SPECIAL AIRWORTHINESS INFORMATION BULLETIN

No. CE-01-11
February 7, 2001

11-JK1275

TITLE: PLACARDS AND MARKINGS - INTRODUCTION OF FIRE EXTINGUISHER INLET LABEL TO BAGGAGE BAY BULKHEAD IN REAR VESTIBULE AREA

POSITIONING OF THE NEW LABEL
FIGURE 1

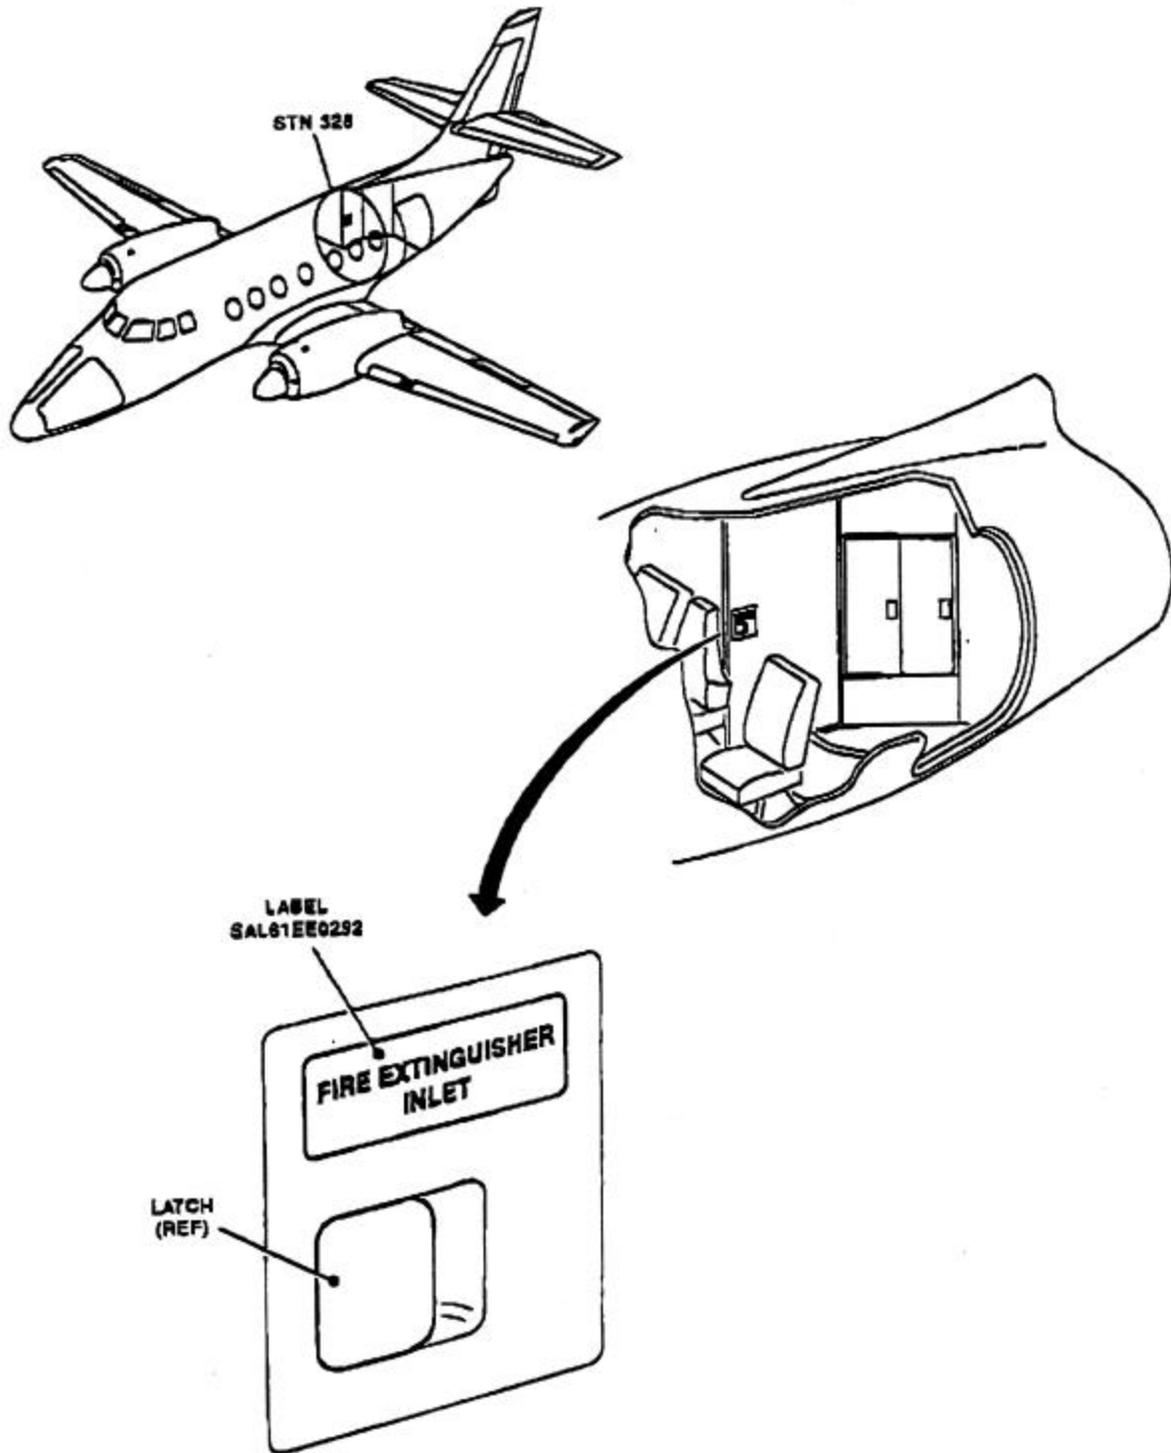
This service bulletin installs a revised label on the baggage bay bulkhead above the access panel to the extinguisher inlet port. The revised wording clarifies the function of the panel and meets the intent of the FAA Safety Recommendations 00.045 to 00.47B.

- (1) Refer to SRM 51-00-00. Remove any existing associated labels on or around the access panel at the baggage bay bulkhead in the rear vestibule before installation of the new label.
- (2) Refer to Figure 1 and SRM 51-00-00. Clean the area shown for the attachment of the new self-adhesive label with an approved solvent.
- (3) Refer to Figure 1. The label SAL61EE0292 should be attached above the latch on the access panel at the baggage bay bulkhead in the rear vestibule in a convenient and easily viewed location.
- (4) Ensure all areas worked in are clean and free from dirt, tools and loose articles.

NOTE: It is the operators responsibility to install and manufacture an equivalent label in dual language if required. The label should read 'FIRE EXTINGUISHER INLET' and its appropriate language translation should be written below this with correct label size, font size, and colour.
